Neil Blandford's Technical Comments on Goliad Project's Well's Pump Test

The attachments are excerpts from a report prepared and presented by Neil Blandford of Daniel B. Stephens & Associates, Inc. on behalf of the Goliad County Groundwater Conservation District (GCGCD). Blandford was one of the attendees to the meeting of February 28, 2011, between GCGCD officers and their expert witnesses, and members of the Region's technical staff.

GOLIAD TCEQ HEARING

**Plot of Drawdown Through Time for
PTW-1 Aquifer Test from UEC PA-1 Application**

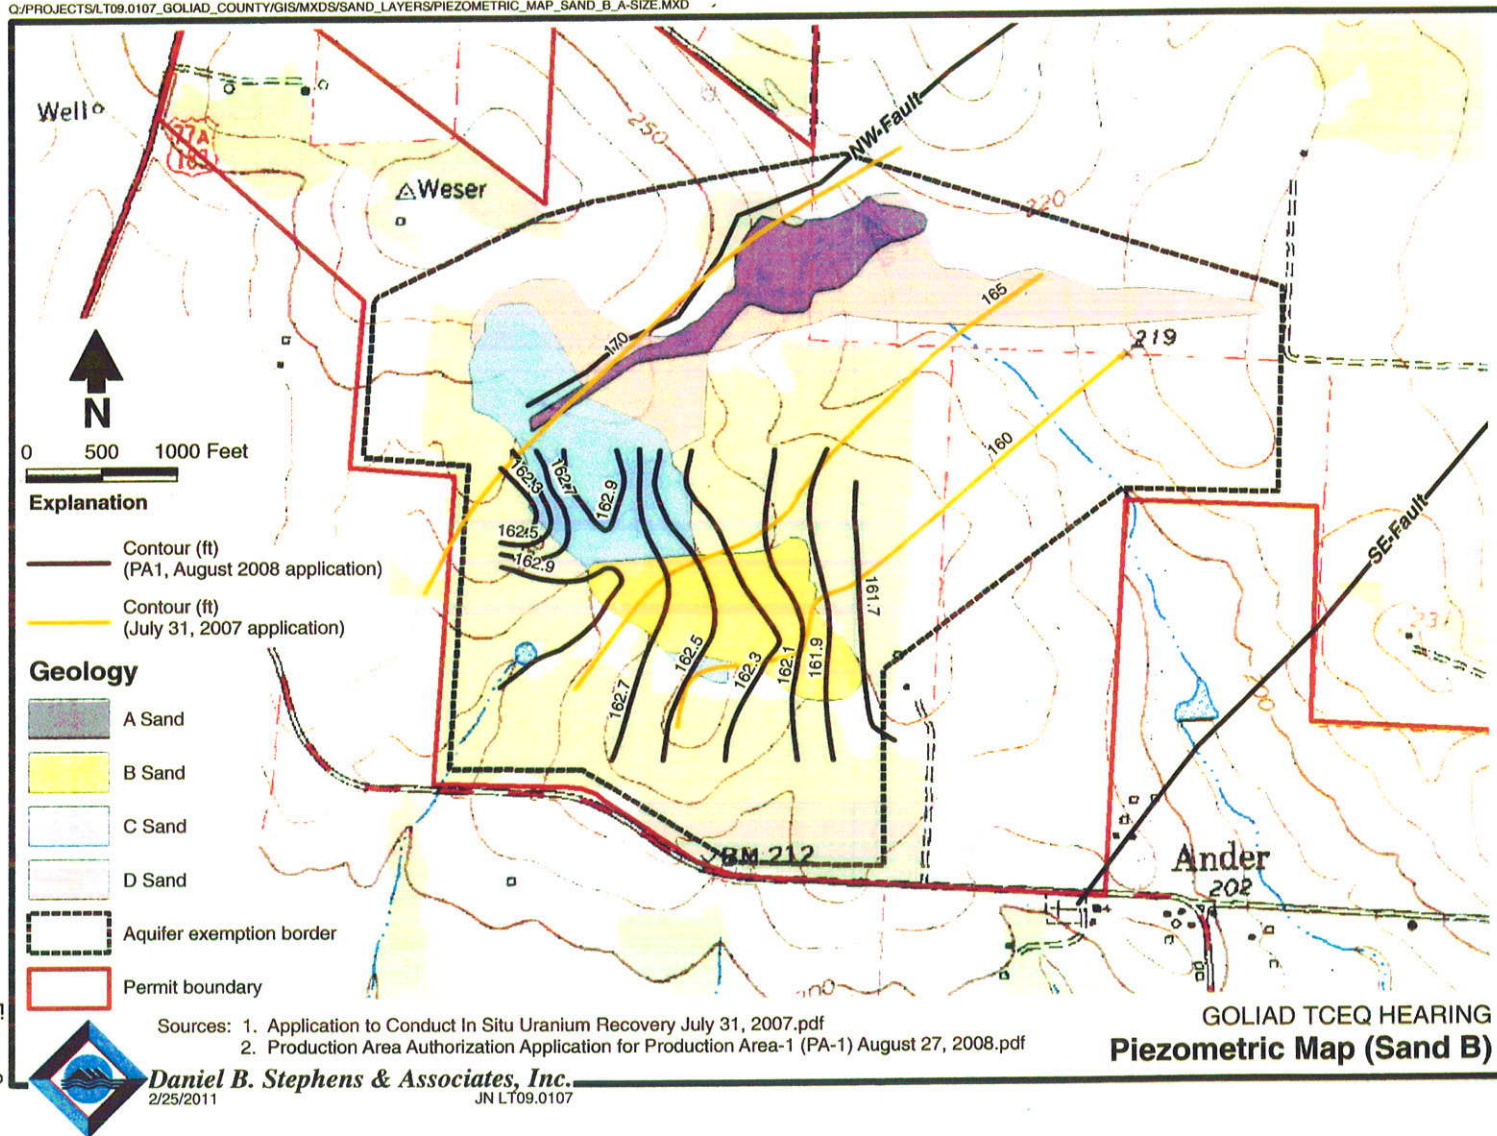
One other thing to look for in Blandford's presentation is his analysis of the discussion presented by the applicant in connection with the pump test of a well inside the perimeter of proposed PA-1. Blandford points to the characteristic of the curve recorded for a well located to the West of the pumped well. This curve, Blandford points out, supports a conclusion that contradicts the one presented in the operator's report. Blandford seems to indicate that the test actually proved communication between Sands A and B at the proposed PA-1.

- ♦ p. 4-23; “Figure 4-10 shows that there was a very slight increase in water levels in OMW-1 during the PTW-1 test. If there were hydraulic communication between the pumped Sand B and Sand A, there would be an obvious decline in the water level of OMW-1”

G:\PROJECTS\LT09 0107 GOLIAD COUNTY\GIS\EXHIBITS\EXHIBIT F-AQUIFER TEST WELL LOCATIONS.MXD

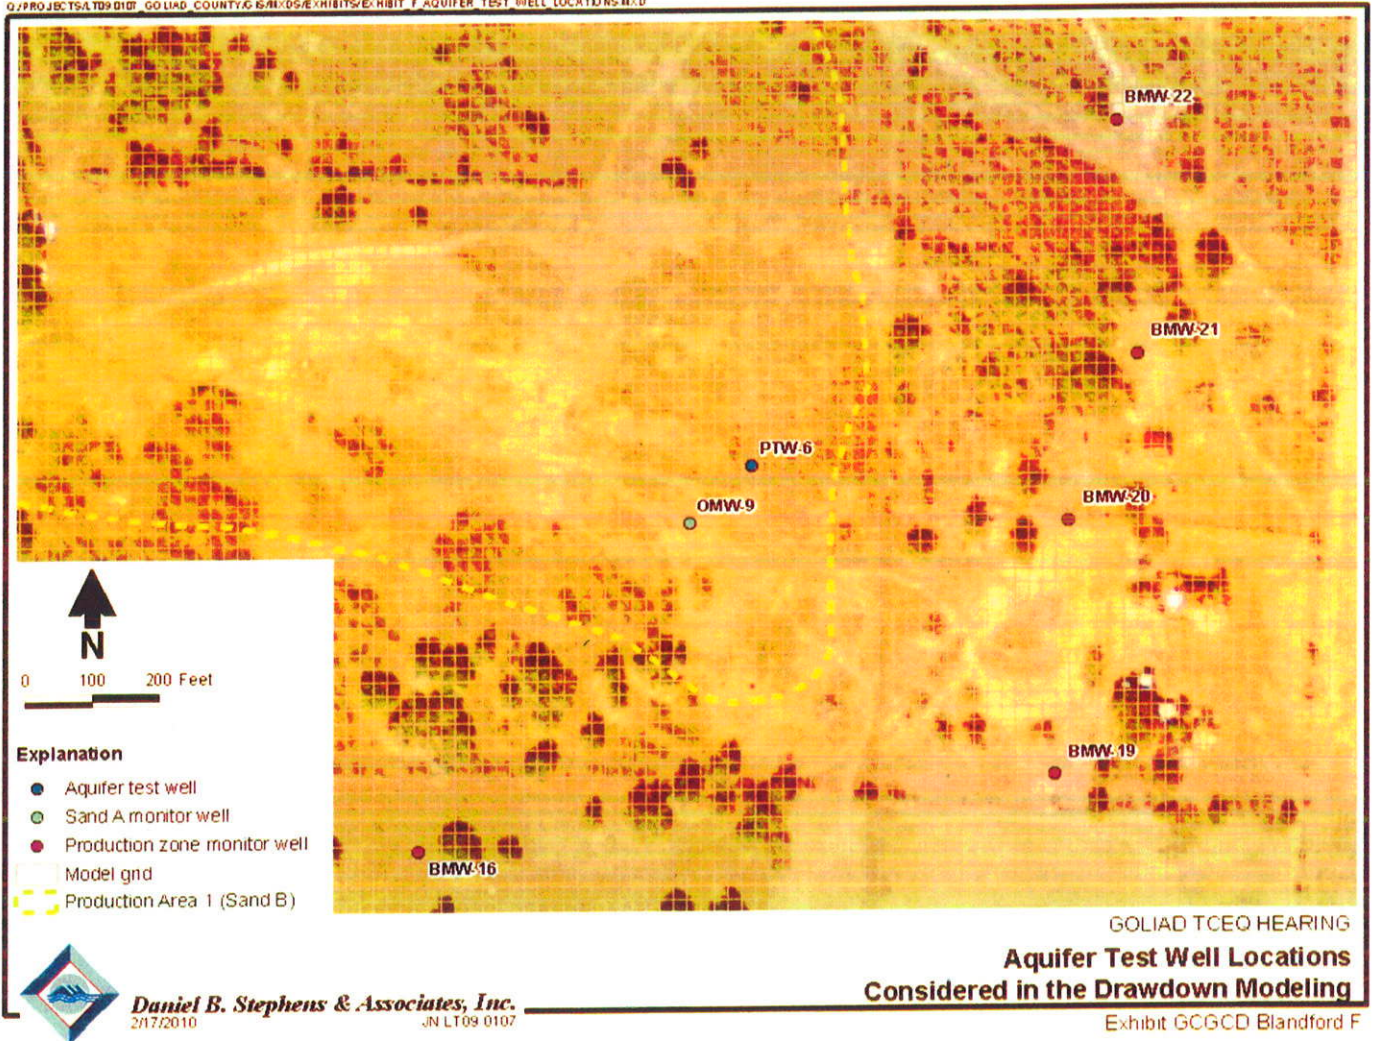
- 
- ♦ Numerical simulation of the PTW-6 test indicates that expected drawdown in Sand A monitor well OMW-9 would be 0.05 ft or less due to the pumping from Sand B well PTW-6 for the test
 - ♦ Claims made by applicant regarding vertical communication between Sand B and overlying Sand A are not substantiated by their aquifer testing

Cross Section of Groundwater Model Used for PTW-6 Aquifer Test Analysis

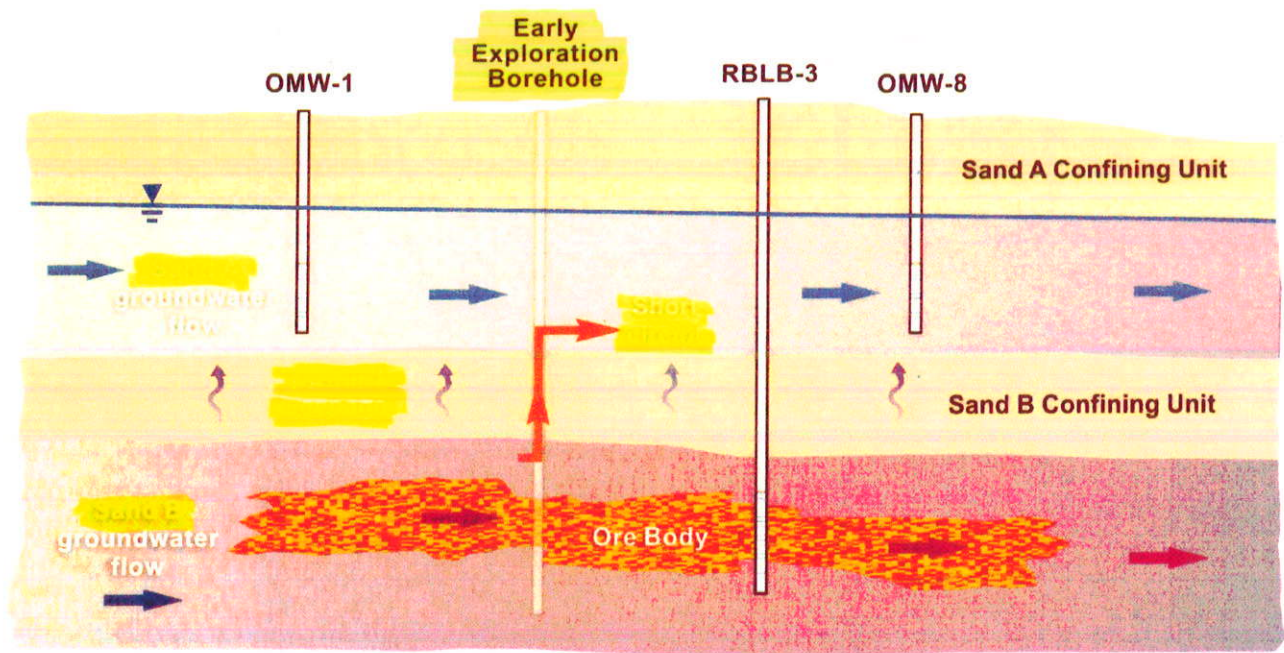
Finally, Blandford refers to the characteristics of the flow inside the two sands pointing to the crossflow between sands made possible by the presence of improperly plugged exploration wells and seepage. He also discusses some modeling runs. Hope this helps.
